HARRINGTON AVE., LONG ISLAND 93-1-2

# APPLICATION FOR PERMIT

AP Harrington Ave., Long Island

Building permit for construction of an addition 7'x16'-8" on the side of your dwelling on Harrington Avenue, Long Island, is issued herewith directly to you at the request of Mr. Nelson, who applied for it. It is issued subject to the conditions listed below and, if for any reason you are unwilling or unable to abide by these conditions or if you do not understand what is meant, no work is to be started and the permit is to be returned to this office for adjustment. Conditions under which the permit is issued are as follows:

FIGURES IN RED ARE  
THOSE GIVEN BY MR  
NELSON ON 2/17/52

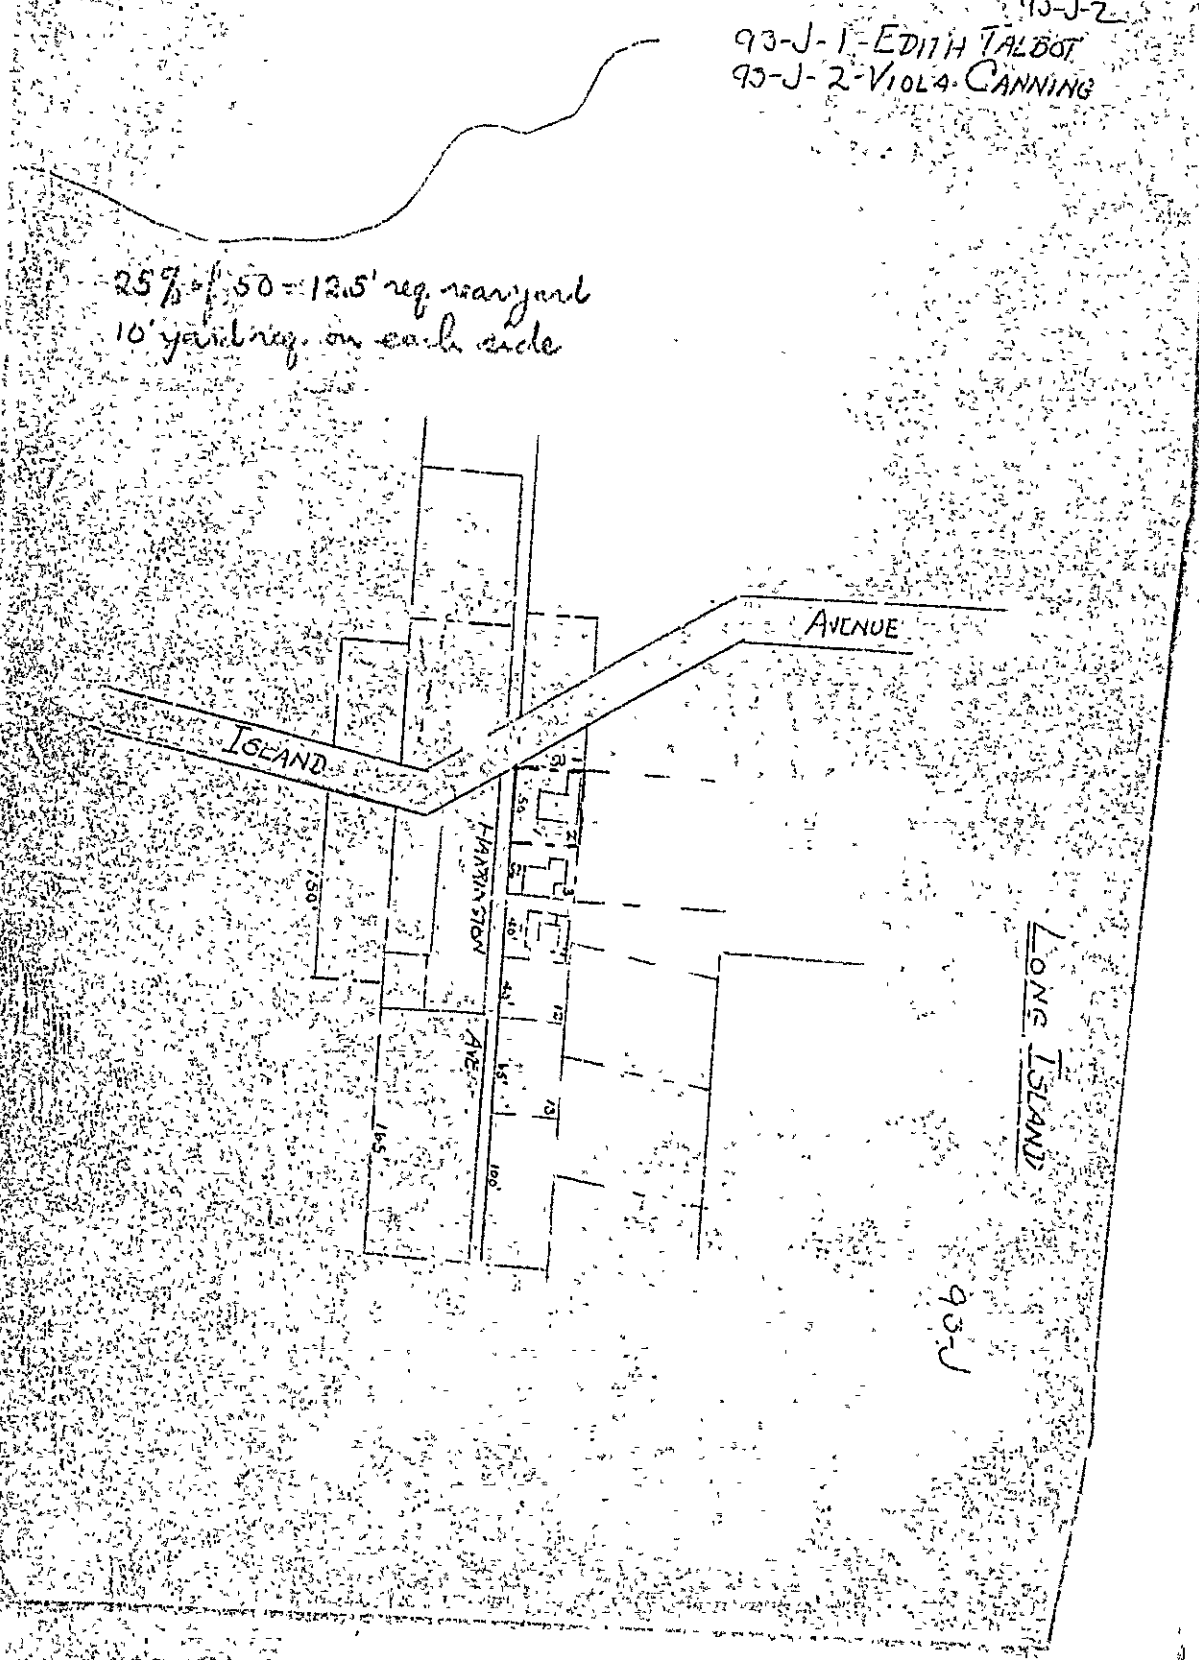
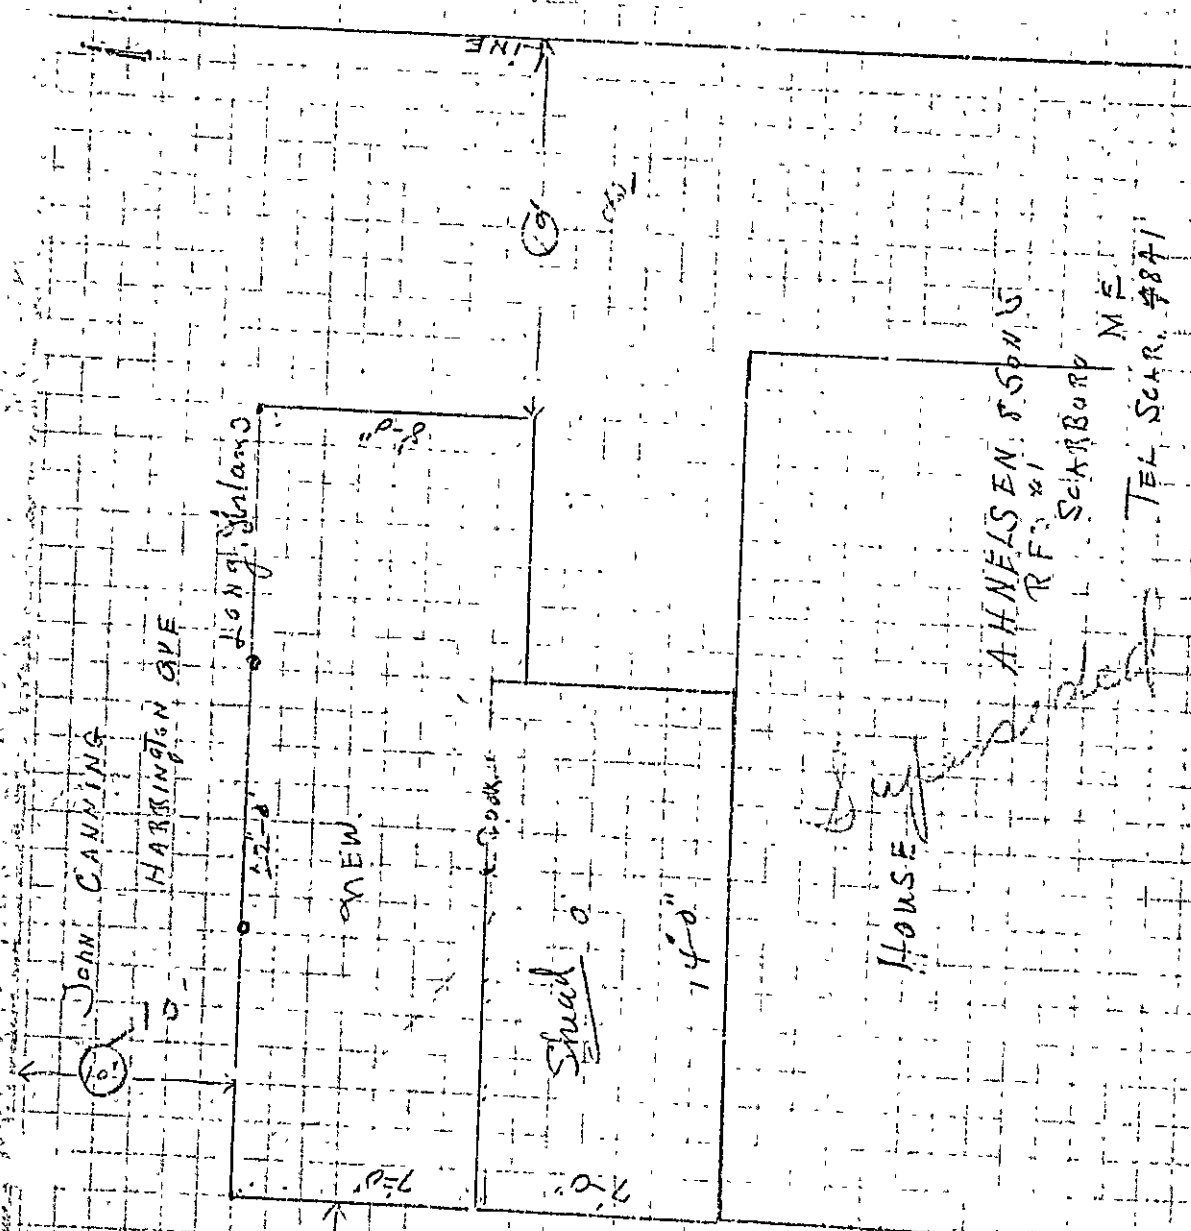
1. The distance between the rear wall of the addition and the rear lot line is to be only 8' whereas a distance of at least 12'-6" is required by Section 8B of the Zoning Ordinance applying to the Apartment House Zone where the property is located.

3. It is not clear how the size of the addition will lend itself to the 6' spacing of cedar posts beneath the sills as indicated in the application. Apparently the normal spacing nearest to this would result in spans of about 7', which is too long for the 4x6 sills indicated except for where the hipped sections of the roof are located.

2. The rear wall of the addition is to be no closer than 12'-6" to the rear line of the lot, this being the minimum rear yard distance set by the Zoning Ordinance. The new location plan indicates a distance of 13' between the side of the addition and the side lot line. This is ample to comply with Zoning Ordinance requirements, which set a minimum of 10' for a side yard width.

3. The 4x6 sills are required to be all one piece in cross section, not built up of two pieces of 2x6, and are to be set with the 6" dimension upright. The 2x6 floor timbers are to rest on top of the sills or, if cut in between them, are to be notched over no less than 2x3 nailing strips spiked to the sides of them.

4. Since the addition is to project closer to the street than the present ell of the building to which it is to be attached and is to extend over to the main building at this projection, the front of the addition will be 14' or 15' wide. The 2x6 floor timbers will not figure out on a span of this length and therefore it will be necessary to provide a 4x6 girder at the center of the span. This girder will need to be supported by posts at the front corner of the existing ell and at the point where it connects with the front wall of the addition.

5. The addition is to be supported on cedar posts extending at least 4' below grade or to ledge, if that is found at a lesser depth. On the long side of the addition there are to be three intermediate posts besides those at the corners.
